**RE: Commercial & Apartment Building – Phase I  
4<sup>th</sup> St NW and Freeman Ave NW  
Grading and Drainage Plan  
Engineer's Stamp Date 11-23-2015 (File: G14D066)**

Based upon the information received in your submittal received 11-23-2015, the above referenced Grading and Drainage Plan is approved for Building Permit. Please attach a copy of this approved plan in the construction sets when submitting for a building permit.

RE: Commercial & Apartment Building – Phase 1, 4419 4<sup>th</sup> St NW  
Grading and Drainage Plans, Revised 11/23/2015 (File: G14/D066)

DRAWING TITLE: **Grading Plan**

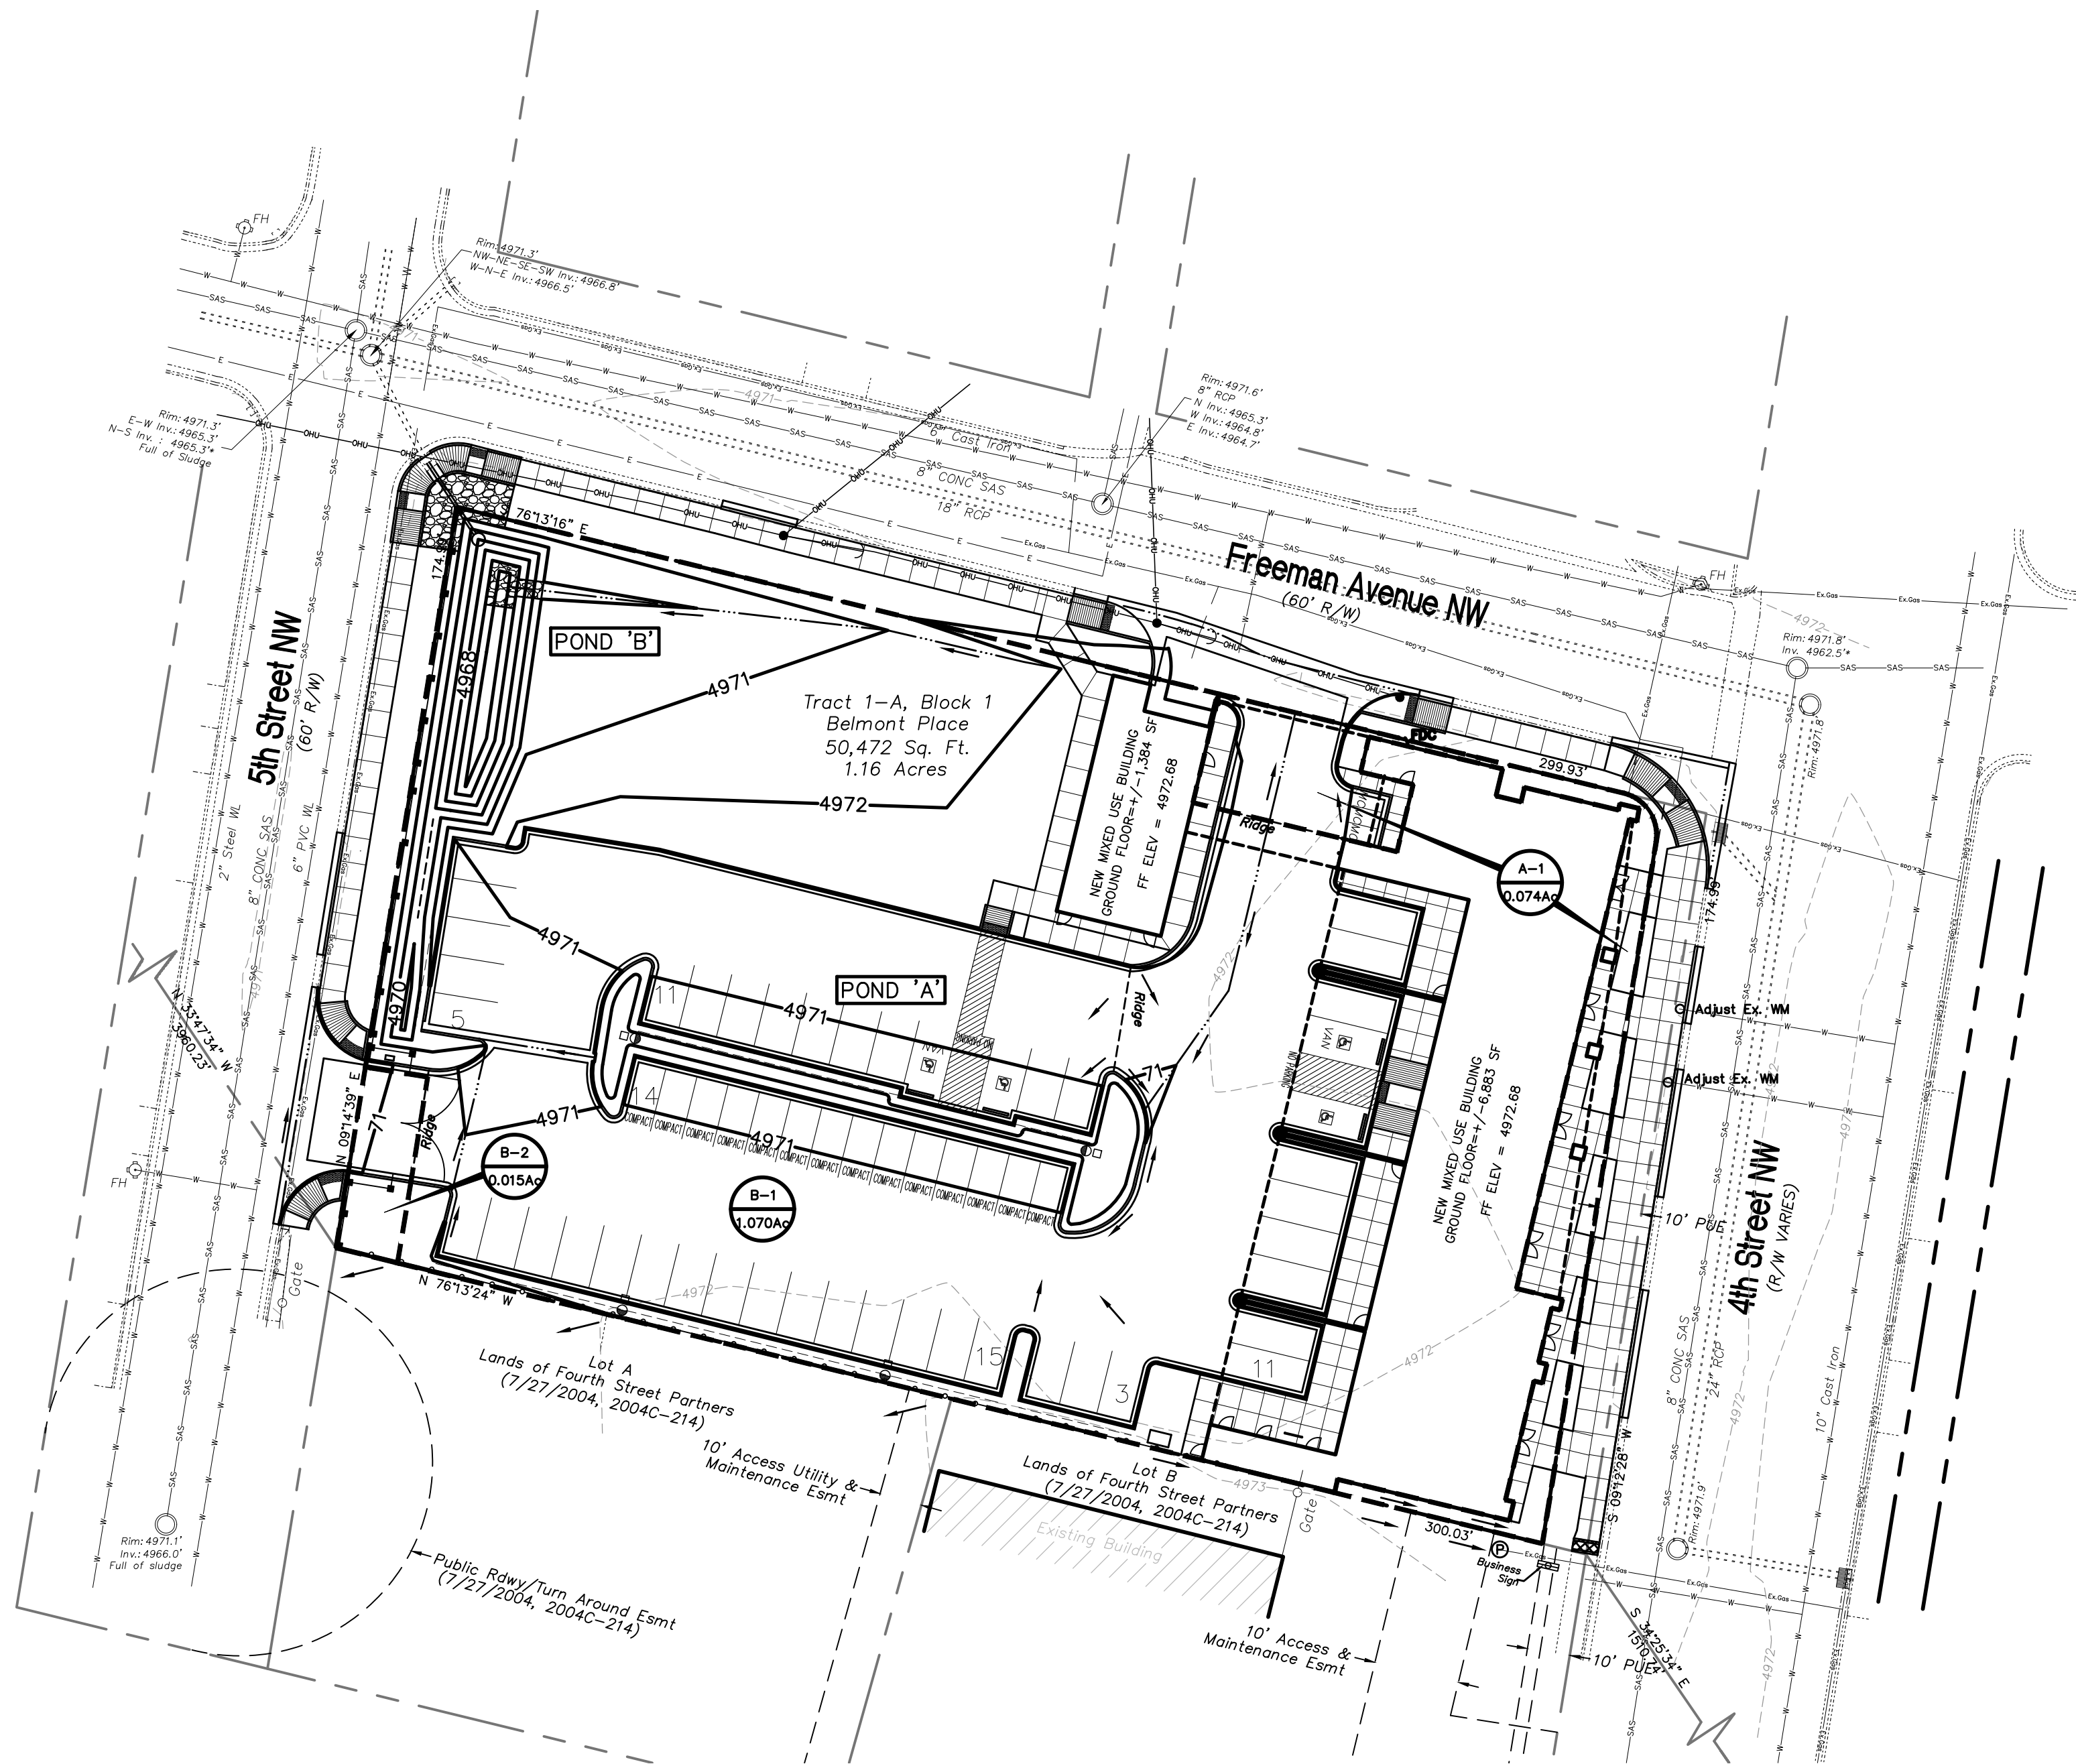
1. Per our phone discussion on 11/20/15 we have removed the statement about accepting 'any offsite flows'. The flow in question was a very small area at the southeast corner of our site which will flow along the property line and not across the site. All other flows on the property to the south are contained on their site. An easement will not be required.
2. We have added some cobble at the northwest corner of the site to minimize erosion from the pond's potential overflow discharge.
3. The curb openings were already called out on the TCL plan, which you likely did not receive a copy. We have added notes to the Grading Plan as well identifying the curb cut locations.
4. The necessary notes have been added to the plans showing that work within the right-of-way will be per separate work order. We also removed the SO-19 notes.

5. A cross section of the proposed pond outfall has been added to the plan.
6. We have updated the notes on the plan to show the pipe connecting to the existing inlet as a 12" HPPP pipe.
7. A note regarding the smooth transition has been added to the plan.
8. We have addressed the comments from the transportation department and the changes to the site plan are reflected on the attached revised plans.
